CASE COMMENT REPORT

CASE NO. UDP-S24057

CASE:	UDP-S24057
MEETING DATE:	October 22, 2024
REQUEST:	Site Plan Level IV Review: Public Purpose Use for 45,953 Square-Foot Community Recreation Facility and 12,951 Square-Foot Emergency Clinic with Associated Parking Reduction
APPLICANT:	City of Fort Lauderdale
AGENT:	Andrew Schein, Lochrie and Chakas, P.A.
PROJECT NAME:	YMCA/Broward Health at Holiday Park
PROPERTY ADDRESS:	840 N. Federal Highway
ZONING DISTRICT:	Boulevard Business (B-1) and Parks Recreation and Open Space (P)
LAND USE:	Commercial and Park and Open Space
COMMISSION DISTRICT:	2 – Steven Glassman
NEIGHBORHOOD ASSOCIATION:	Victoria Park Civic Association
CASE PLANNER:	Lorraine Tappen

UDP-S24057 - 840 N FEDERAL HWY

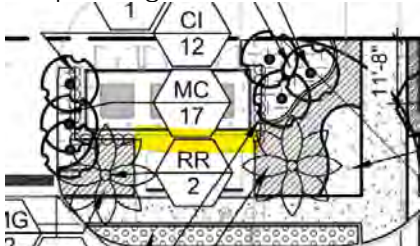
7. The use of structural soil is required in paved sites to provide adequate soil volumes for tree roots under pavements, as per ULDR Section 47-21.13. This requirement is applicable to all site trees, including VUA island trees, and not just street trees as currently proposed. Structural soil details and specifications can be obtained at <http://www.hort.cornell.edu/uhi/outreach/index.htm#soil> This is to be provided at a minimum of 8' radii of tree trunks, and is to be consistently illustrated and noted on landscape, site and civil plans.

The structural soil drain is required when percolation rates are less than 4" vertical clearance per hour. Provide documentation of report used to prove this calculation. The drain and connections are to be illustrated on civil plans.

- a. Demonstrate hashing on landscape, site, and civil plans as to the extent of use of the Structural Soil.
 - b. Provide Structural Soil Detail and composition.

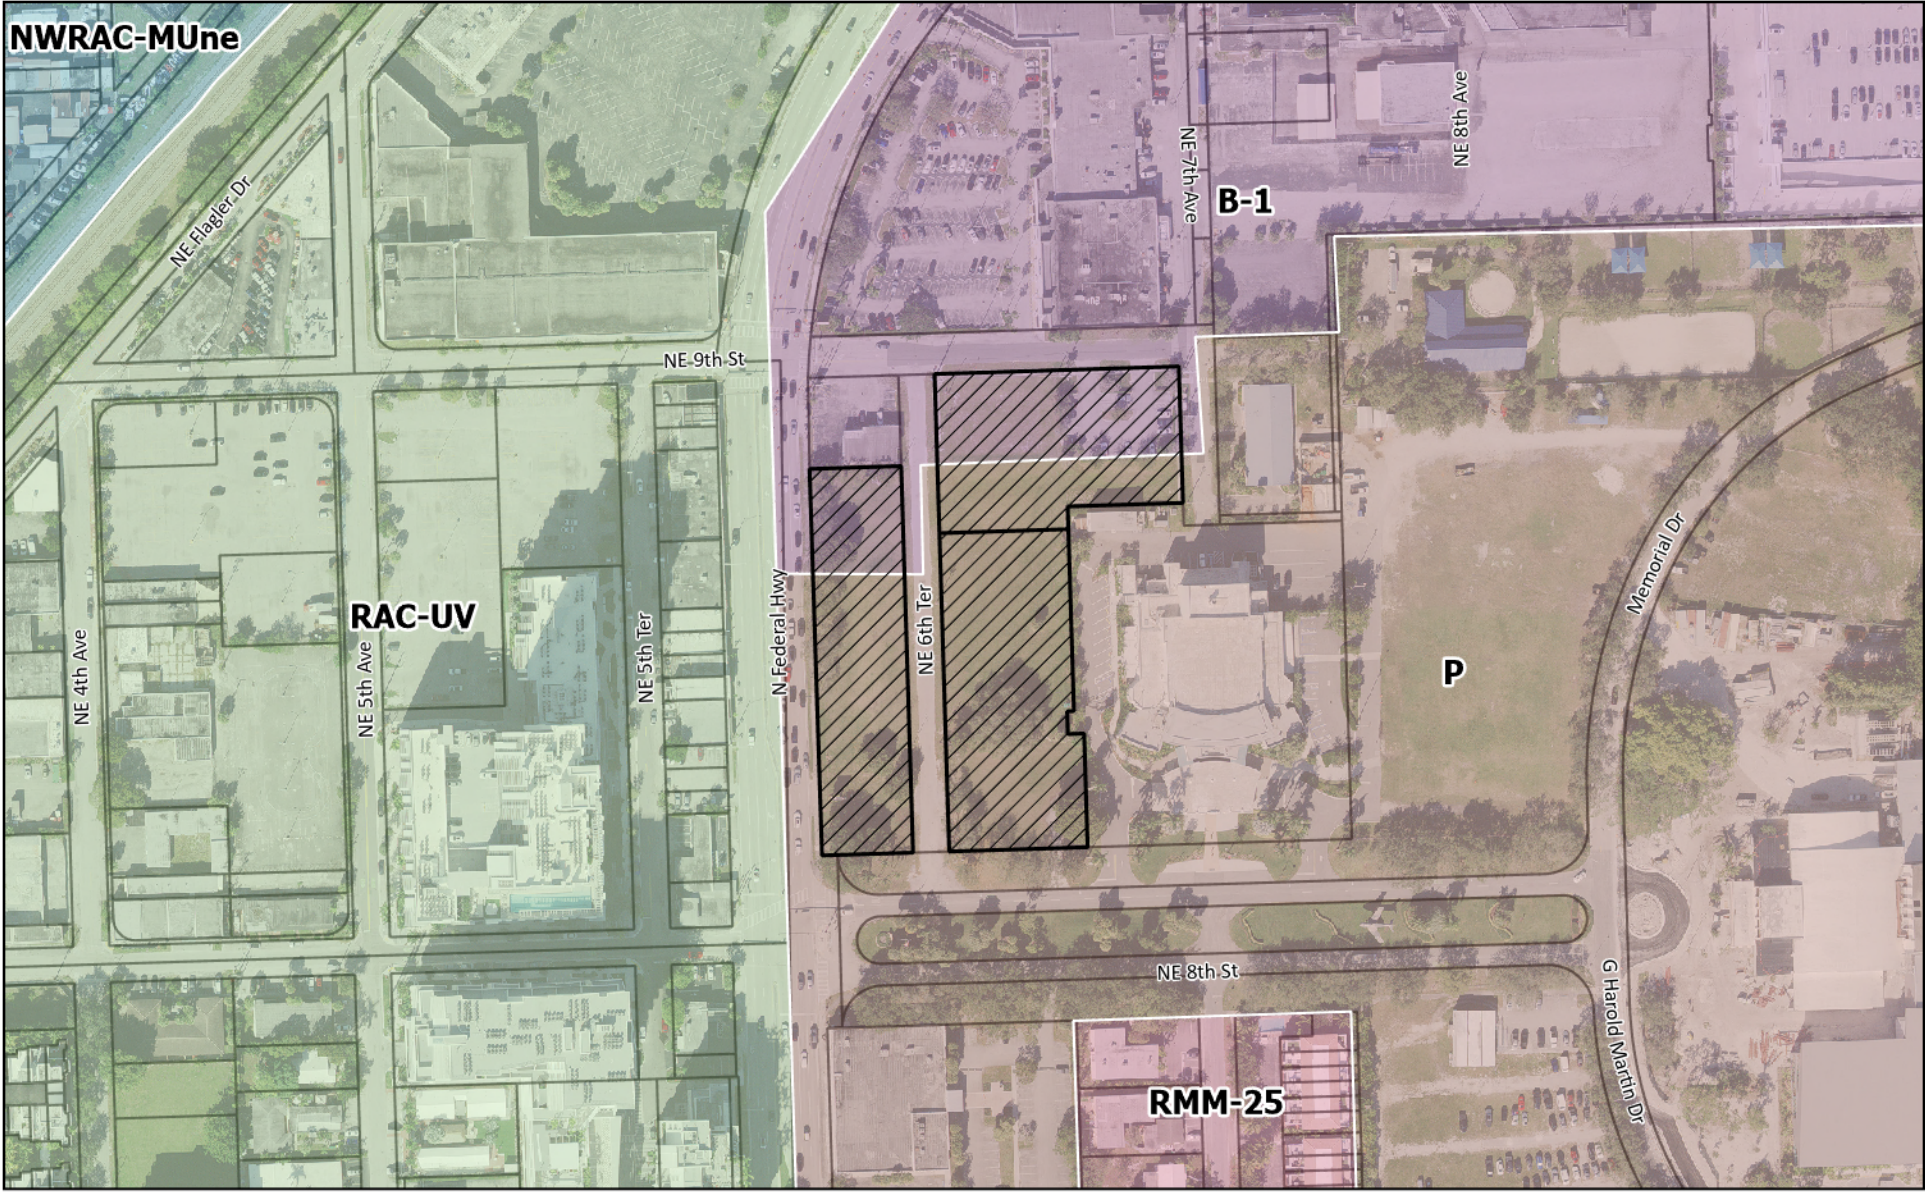
7. As proposed, the overall site design internalizes the active entrances toward the east and creates a nonactive frontage along the public realm both on Federal Highway and NE 8th Street, which is the future LauderTrail connection. There should be a stronger presence fronting Federal Highway by creating significant architectural building features and entrances to the west and south. In addition, there should be more transparency, variation in the roofline, a variety of high quality materials, and sense of place elements like public art or creative building illumination. Further evaluation is needed regarding the location of the pool, breaking-up the 400 foot streetwall length along Federal Highway with potential paseo, or other building breaks that allow visibility into the park. See images below.

Building Design

Transparency

Active Roof
